CITY OF KELOWNA

MEMORANDUM

Date: June 5, 2003
File No.: BL7900
To: City Manager
From: Development Engineering Manager
Subject: Subdivision Bylaw – Hillside Development Updates

PROPOSED HILLSIDE ZONE STANDARDS LOCAL ROAD – OPTIONAL SIDEWALK	SCALE 1:150
			DATE JUNE 3, 2003
			DES DWN TF
			CKD APP
			PROJ. No. 03/011
			JAGS, Inc.
			TYP-01SW
DATE	REVISIONS

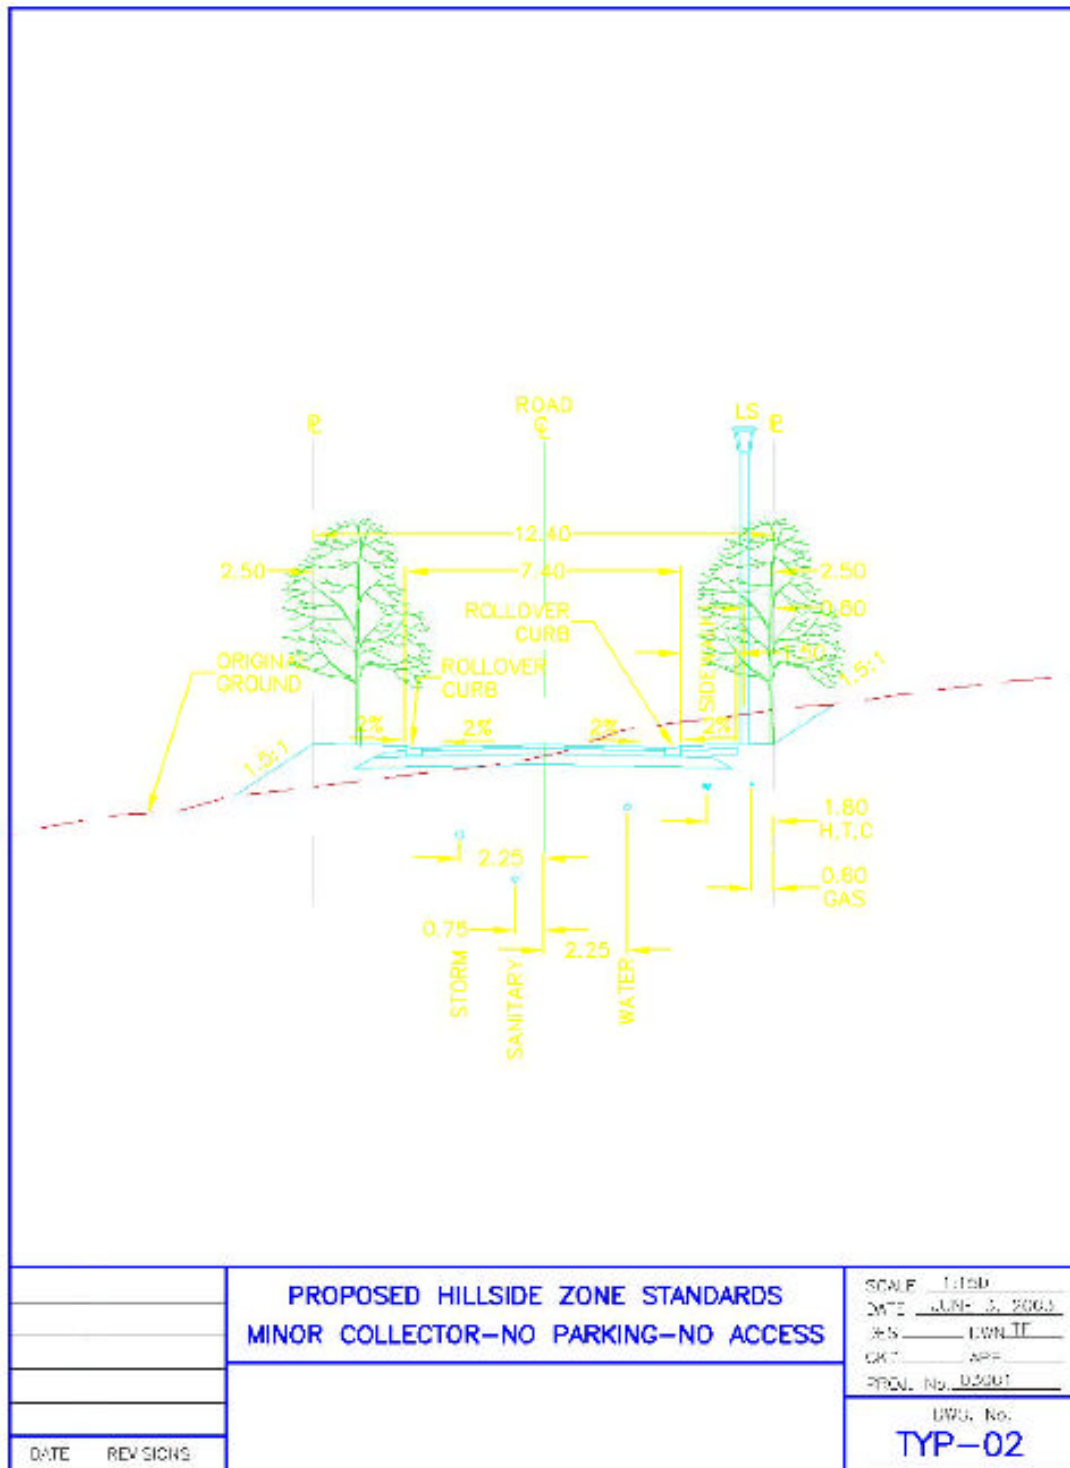
It is recommended that an additional cross section as attached to this report be accepted as an alternative for local hillside roads. The proposed standard would allow developers the option of a sidewalk or not. This standard is consistent with the City's present standard in non-hillside zones where local roads do not require sidewalks. If this added standard is accepted, sidewalks would still be required in areas of higher than normal pedestrian activity such as adjacent schools, accesses to parks and where pedestrian connectivity through the subdivision is required. The proposed local road cross section alternative also deletes the parking bays, in favour of a wider pavement surface that allows on street parking. At 14.0 metres in width this cross section is still narrower than the 18.0 cross section non-hillside standard for local roads. The current standard has parking bays above the curb and a sidewalk, which either meanders around the parking bays or runs parallel to the curb behind the parking bays. It has been found that parking bays, unless developed to a higher standard and tightly controlled by the developer, can result in a less aesthetic streetscape.

THAT City of Kelowna Subdivision Bylaw No. 7900/Hillside Guidelines – Schedule 7 Section 4 be amended by the addition of the cross sections attached to the report of the Development Engineering Manager dated June 4, 2003.
